CITY OF BLOOMINGTON PLAT COMMITTEE

December 10, 2018 @ 4:00 p.m. CITY HALL - KELLY CONFERENCE ROOM #245

CASE #: DP-10-18 DATE: December 10, 2018

REQUEST: The petitioners are requesting final plat approval for a two lot subdivision zoned RS (Residential Single Family).

STURMWATER	KV VOFF	LULLY SUS	
------------	---------	-----------	--

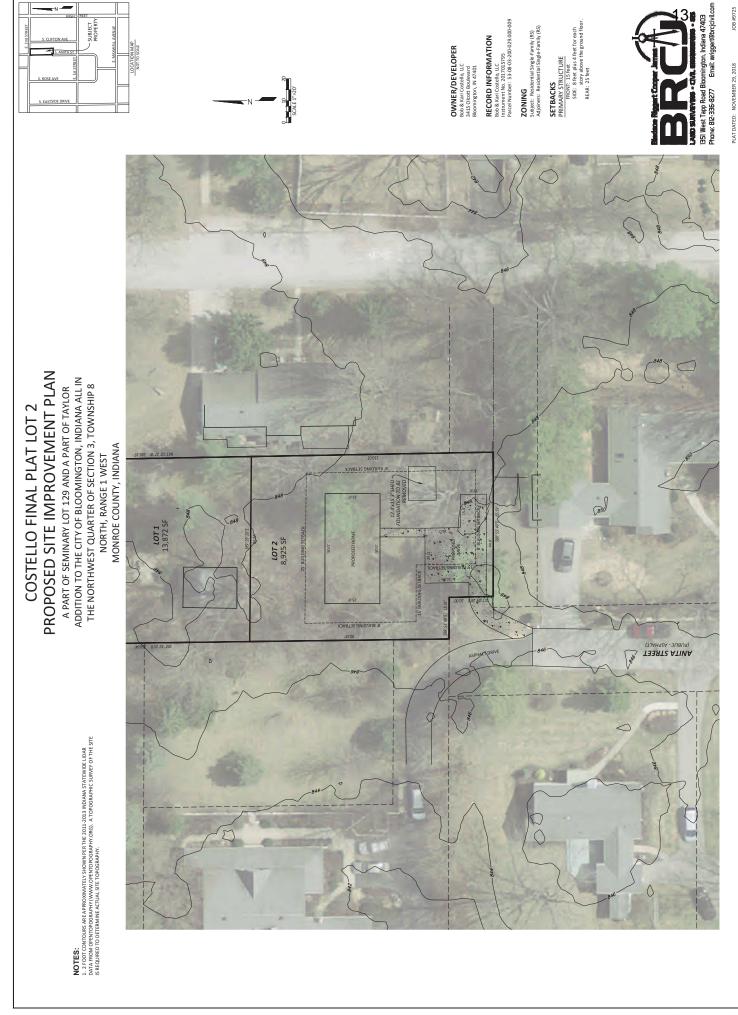
At the Plan Commission hearing for the preliminary plat, several nearby property owners spoke to or submitted letters about existing drainage issues in the neighborhood and concern that future development on the proposed Lot 2 would exacerbate these. The Plan Commission included a condition of approval on the preliminary plat that states, "This approval is contingent upon the

petitioner providing an assessment to staff's satisfaction of whether any legally permitted construction on the proposed new lot would have a negative impact on surrounding drainage problems." To meet this condition the Department had the petitioner submit a drainage study that would show effects on surrounding lots of possible development on the proposed new lot. The study found that based on a potential site plan of the lot, there would be a 100% increase in stormwater run-off though there would be measures that could be taken on the property to minimize this impact including reducing impervious surfaces or using rain barrels. The Department consulted with Phil Peden from City of Bloomington Utilities who said the increase is negligible though the suggestions for mitigation could be implemented. This study is included in the packet. The Department is satisfied that through coordination with City of Bloomington Utilities, tactics can be implemented to mitigate any increase in drainage issues created by a typical residential development.

No environmental constraints are found. While drainage issues have been reported, the City Drainage Engineer believes it is possible to implement measures to mitigate increased runoff on-site.

11 3/4 DETERMINE POST , DEVELOSMENT KUNDER, QPOST = CLA C. COMPOSITE POST DEVELOPMENT RUNOFF COEFFICIENT C = (1,250 (0,95) + 1,014,8 (0,95) + 235,5 (0,95) + (8,925-(1,250+1,014.8)) (0,17)) / (8,925 CHOVEE C PAVEMENT C PAVEMENT BALINCE OF LOT 2 J ON LET 2 IN P/W c = 0,3829 I, RAINFALL INTENSITIES FOR THE 2, 10, AND 100 YEAK EVENTS ARE THE SAME AS THE PAE. DEVELOPED CONDITION. 124000 = 4.28, 110 400 1 5.75, 100 YELL - 7.84 W/HR A, AREA REVIAINS SHE SLAS BY DIZIOJ ACRES Q past = 0.3829 (4,28) (0,2103) = 0,34 CES Qpost = 0,44 CES Qpost 0.63 CES COMPLEISON OF PRE TO POST-DEVELOPED RUNOFF RATES POST. DEVELISES RAINFALL PRG. DOVELOPEL PRE. POST RUNDEE RATE [CES] EVENT [YE] RUNOFF RATE [CFS] INCREASE [CFS] Ζ 0.17 0,34 0.17 10 0,23 0.46 0.23 0,32 100 0.31 0, 63 BASED ON THE PROPOSED IMPROVEMENTS TO LOT 2 WE WOULD ANTICIPATE A 100 % IUCEBASE IN STORMWATER RUNOFF DURING EACH EVENT, EVEN THOUGH THE INDIVISUAL INCREASES AND RELATIVELY MINOR,

12 4/4 THE POST DEVELOPED RUNOFF RATES MAY BE REDUCED BY LINITING IMPERVIOUS SURFACES, INCLUSING A SMALLER ENLYING FOOTPLINT AND LESS DEVED SURFACE AREAS FOR DRIVES, PARKING, AND WALKS, THE USE OF RAIN BARRELS AND/ OR A CISTERN TO COLLECT AND STORE RYMOFF FOR IRRIGATION, TOILOTS, OF WASH COULD BE CONSIDERED. THE SOILS IN THIS AREA ARE TYPE CER, CRIDERIVERAN LANA COMPLEX. THE USDA CONSIDERS THIS SOIL CLASSIFICATION AS WELL DRAINED WITH MODERATE PERMIABILITY AND A PERMIABILITY RATE FANGING FROM 0.6 - 7.0 INCHES PER HOUR, THE USE OF RAIN GARDENS OR PERMIAELO PAVING MAY WORK WELL ON THIS SITE TO LIMIT AN INCREASE IN FUNOFF PREPARED BY BLEDSOB RIGGERT COOPER JAHES WILLIAM S. RIGGERT, PE

TRADES DISTRICT WEST PHASE ONE SUBDIVISION-AMENDMENT PLAT

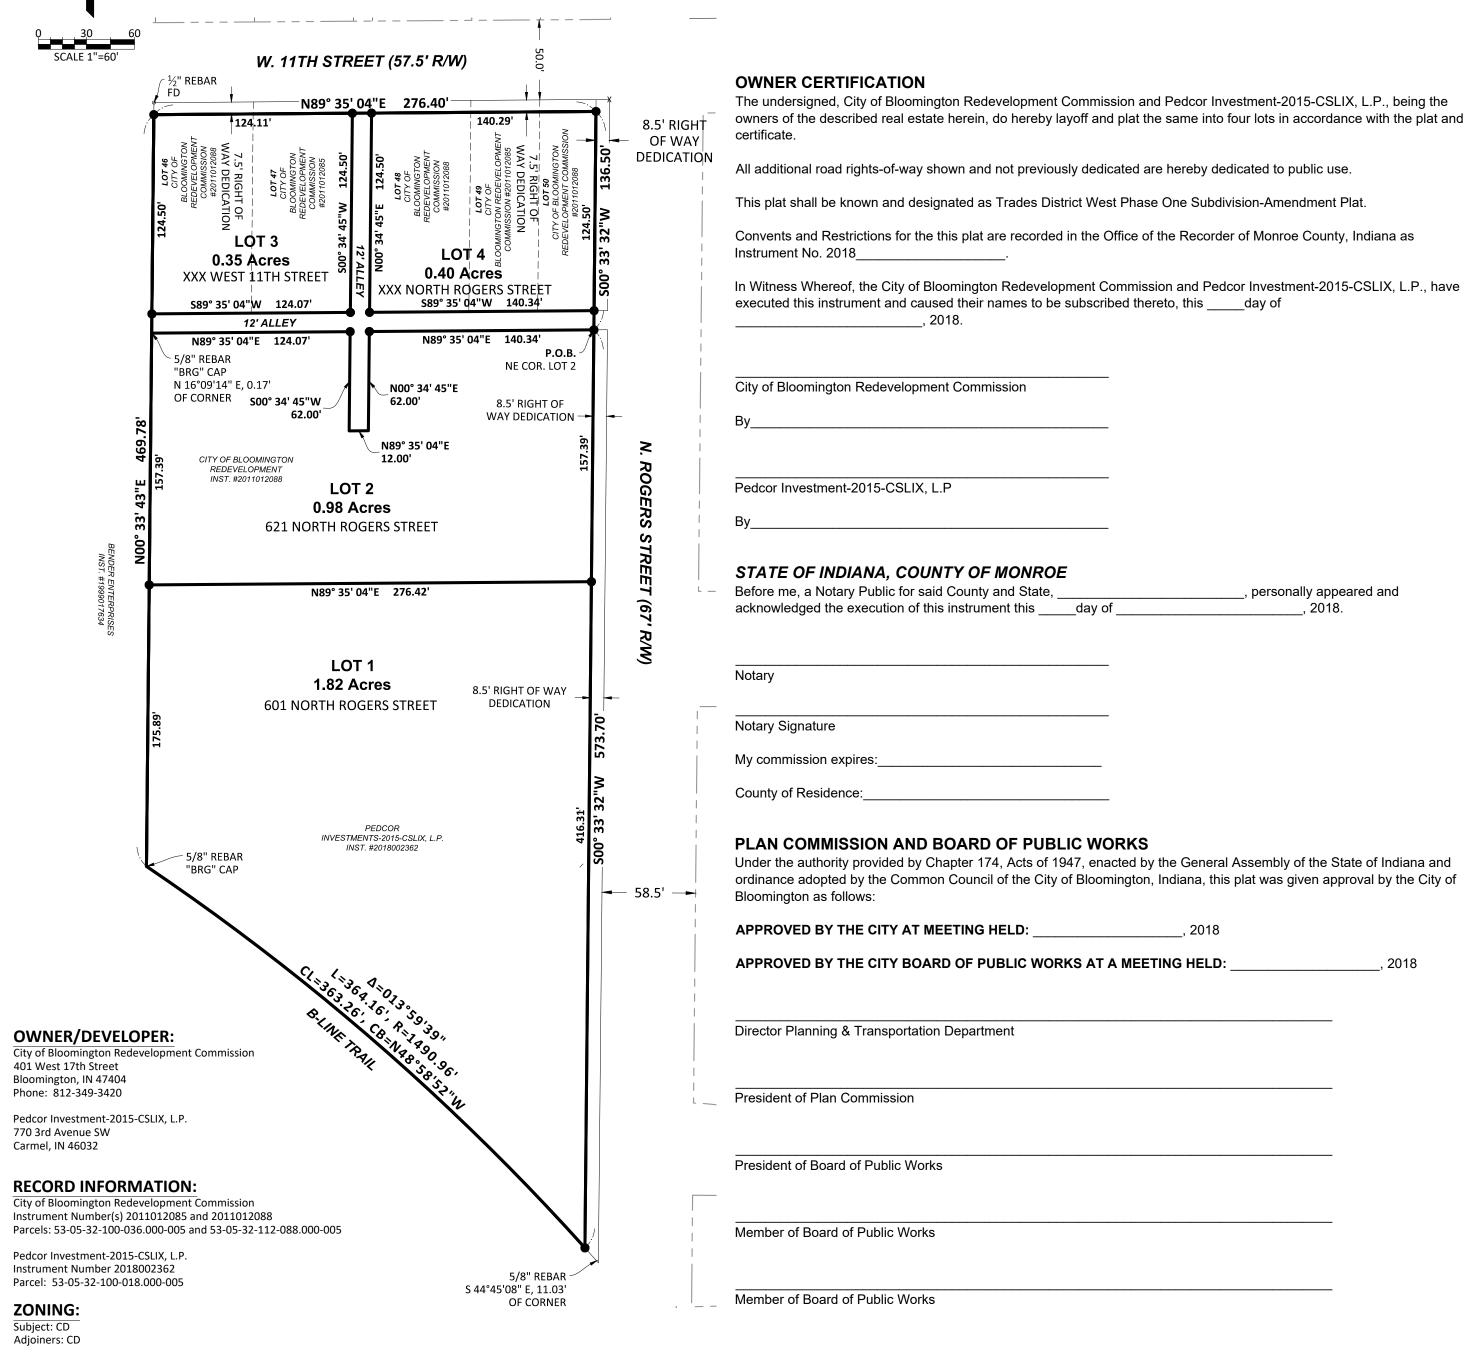
Right of Way: 11th Street is listed as a Primary Collector in the Thoroughfare Plan, requiring 65 feet of right-of-way, resulting in roughly 7.5 feet of right-of-way to be dedicated on the north side with this petition.

When the property to the south was developed, the Plan Commission acknowledged that there would be only an additional 8.5' of right-of-way dedicated for Rogers Street for a total of 33.5' of right-of-way as opposed to the required 40' from centerline. The amount of right-of-way dedicated still allows for the on-street parking spaces, tree plot, and sidewalk to be located in the right-of-way, and is equivalent to the right-of-way needed for the design done for the larger Trades District. The Department proposes to carry that dedication through to these northern lots.

The proposed petition meets UDO requirements with the exception of the right-of-way issue discussed above. All future development on the newly created lots will be required to meet UDO requirements, unless otherwise granted deviation by the Plan Commission or variance by the Board of Zoning Appeals. No concerns were raised by members of the public during the Preliminary Plat process.

1. Plat Signature block will be amended to reflect approval by Plat Committee, as well as correct minor scrivener error.

2. The proposed dedicated right-of-way shown on the plat shall receive approval from the Board of Public Works.

4. The petitioner shall file the Final Plat with the County Recorder's Office and within thirty (30) days provide the Planning and Transportation with a copy of the recorded mylar.
5. The required right-of-way dedication along 11th Street needs to be incorporated and labeled

TRADES DISTRICT AMENDMENT 1 FINAL PLAT **BLOOMINGTON TOWNSHIP** MONROE COUNTY, INDIANA

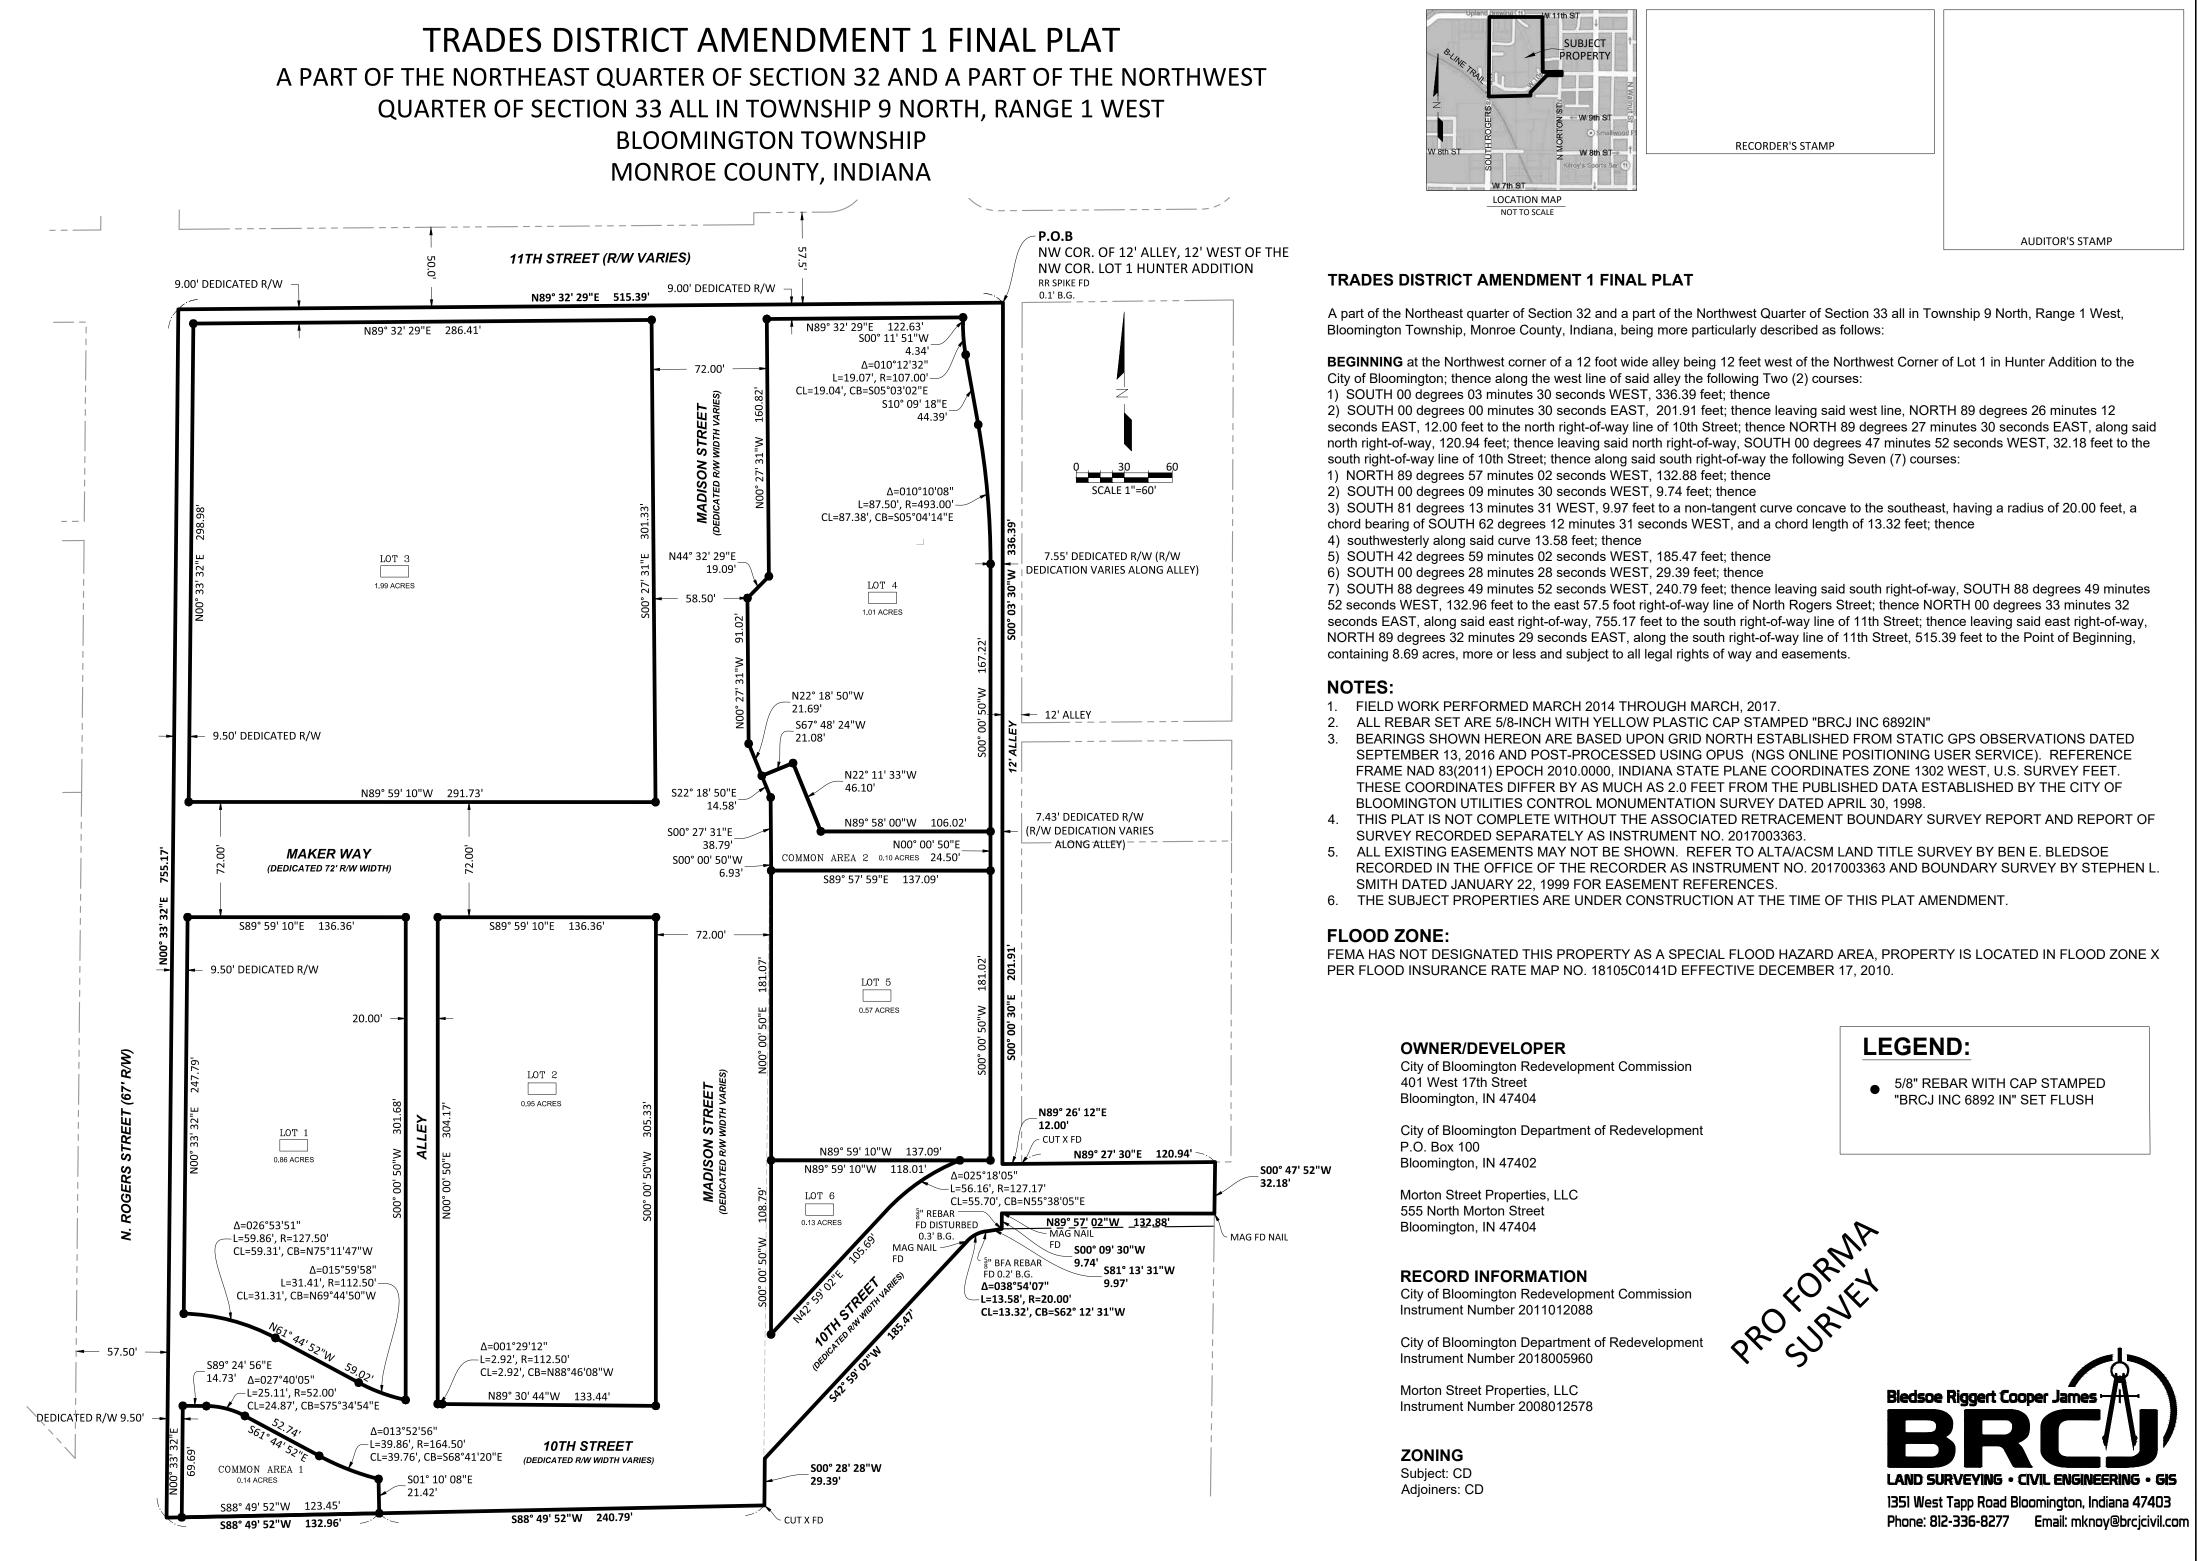
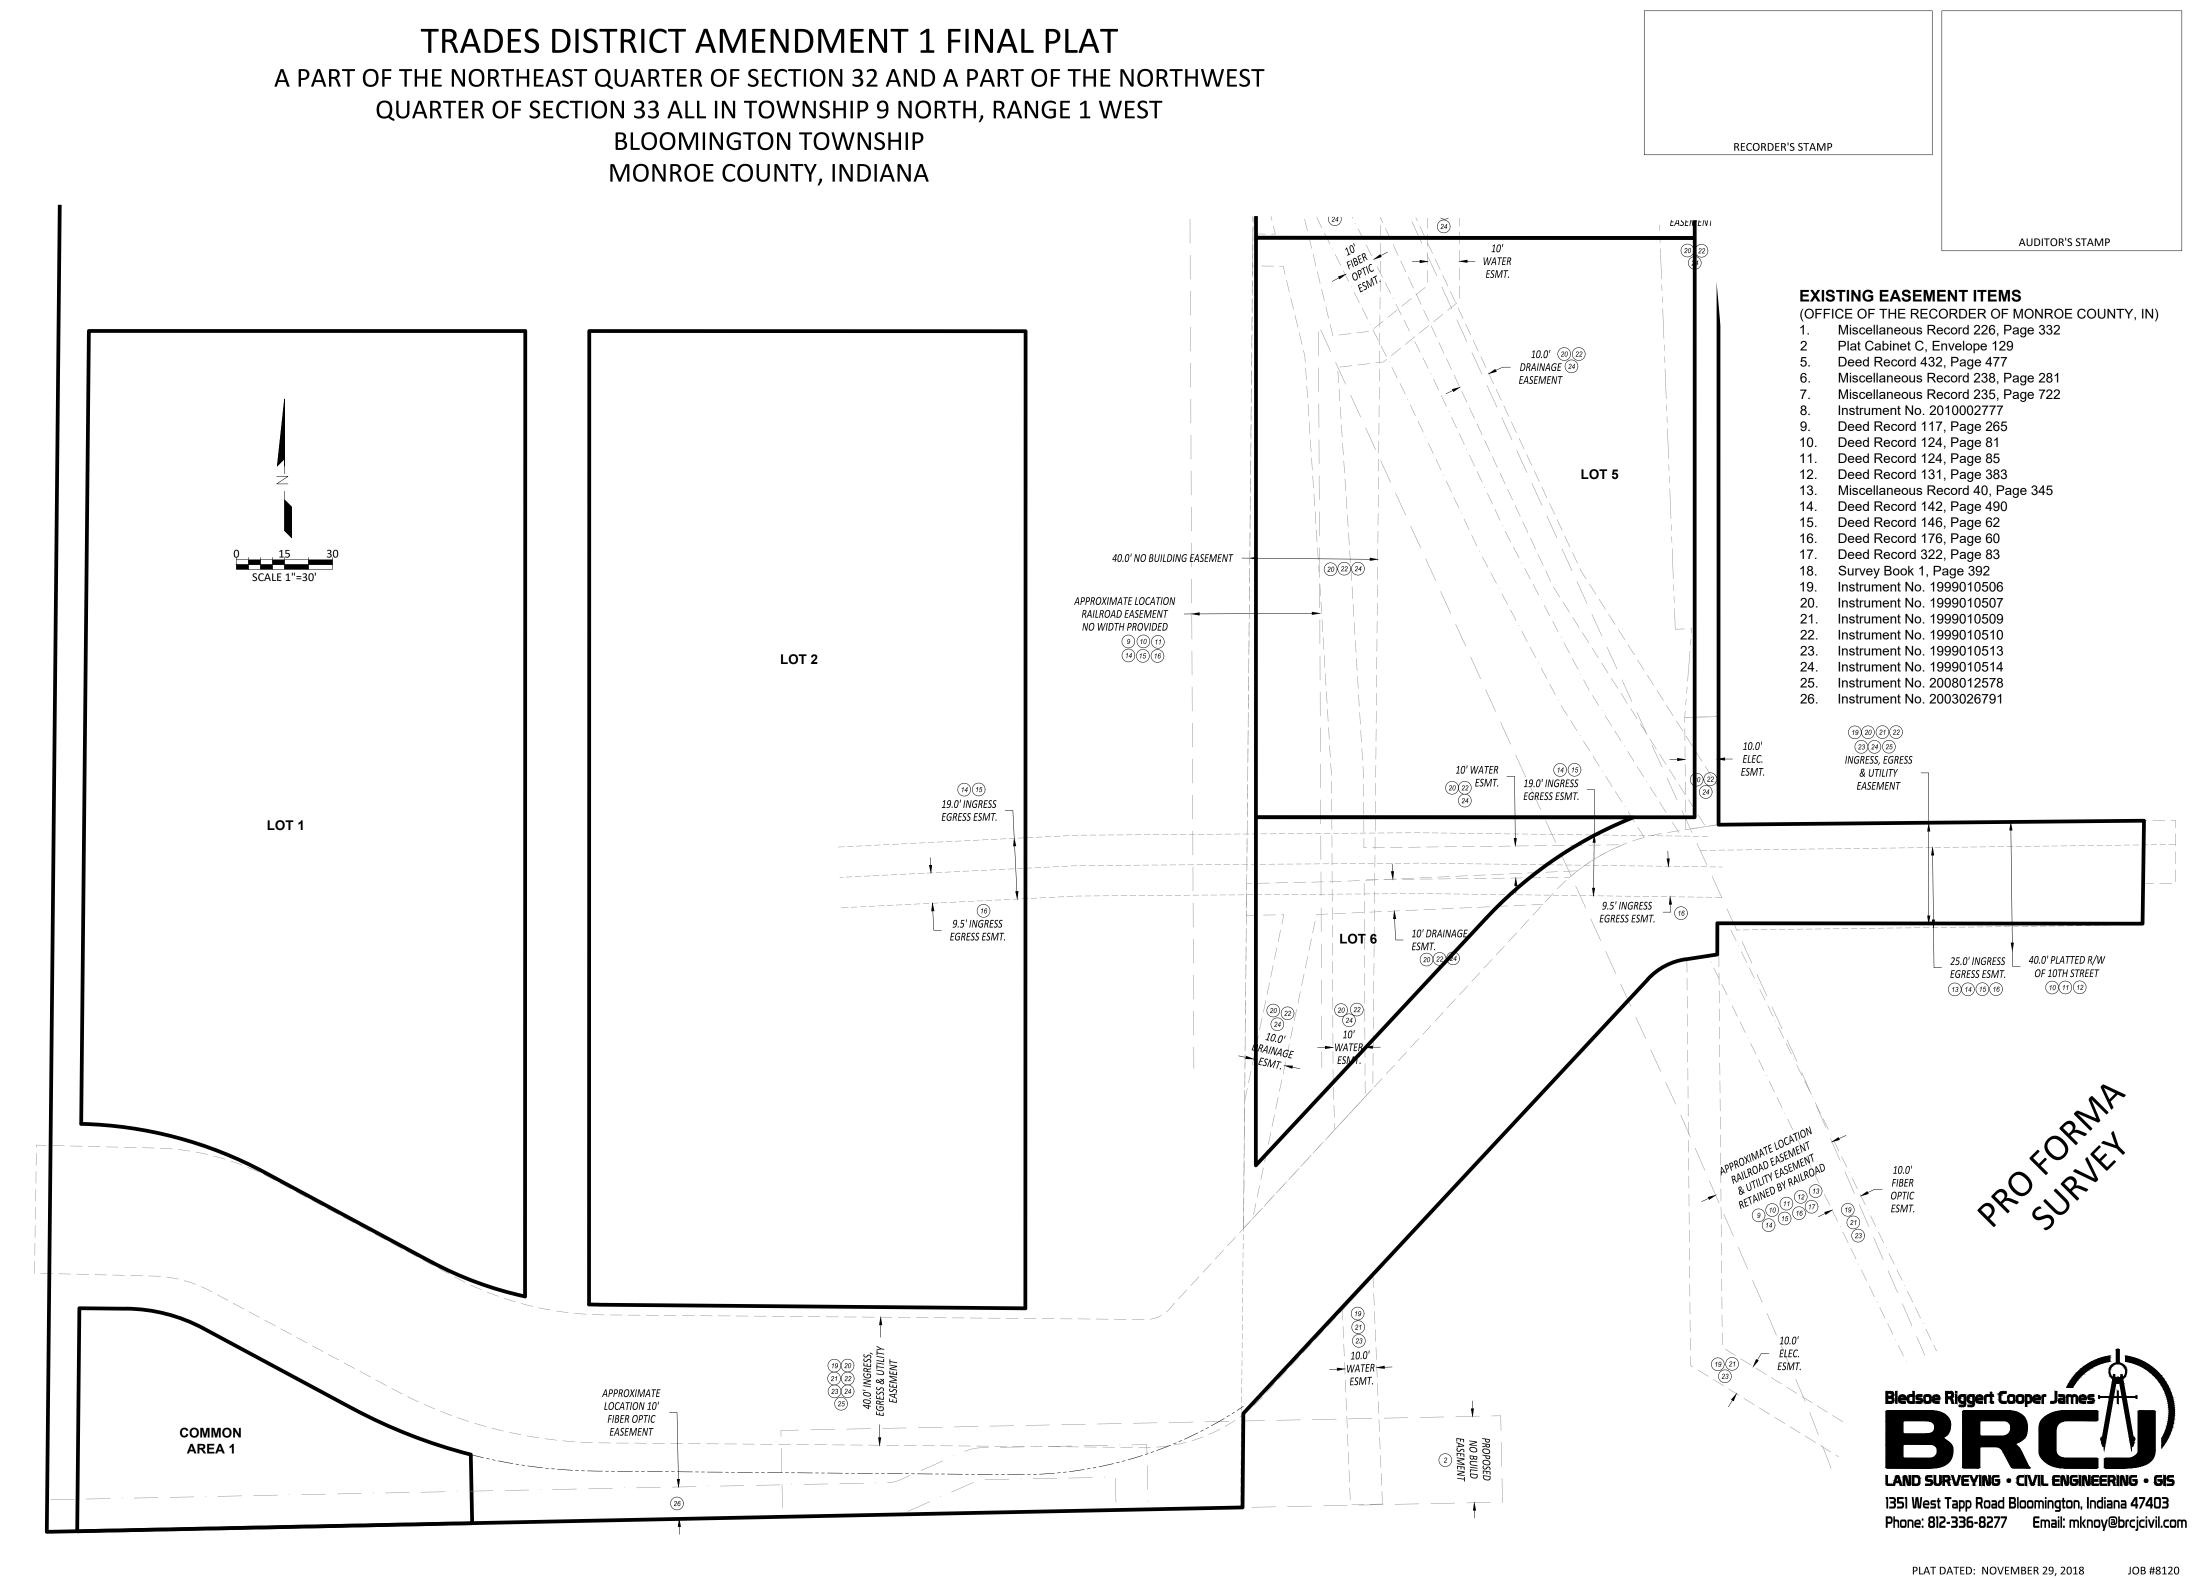
Right of Way: A variable width but roughly 72 foot right-of-way for the new portion of Madison Street is proposed. The right of way will contain room for two travel lanes, on-street parking, sidewalks, planting areas, and green infrastructure water treatment features.

additions in the right-of-way, including tree plat and sidewalk. 9.5 feet of right-of-way was dedicated along Rogers Street in that plat, which amounts to roughly 9 feet lower than the required Thoroughfare Plan width of 40 feet. Department recommends carrying forward that amount with this amendment.

The proposed petition meets UDO requirements with the exception of the right-of-way issue discussed above. All future development on the newly created lots will be required to meet UDO requirements, unless otherwise granted deviation by the Plan Commission or variance by the Board of Zoning Appeals. No concerns were raised by members of the public during the Preliminary Plat process.

1. Plat Signature block will be amended to reflect approval by Plat Committee, as well as correct minor scrivener error.

3. Following all revisions to the Final Plat, the President of the Plan Commission or Chair of the Plat Committee shall sign and seal the plat at the appropriate locations.
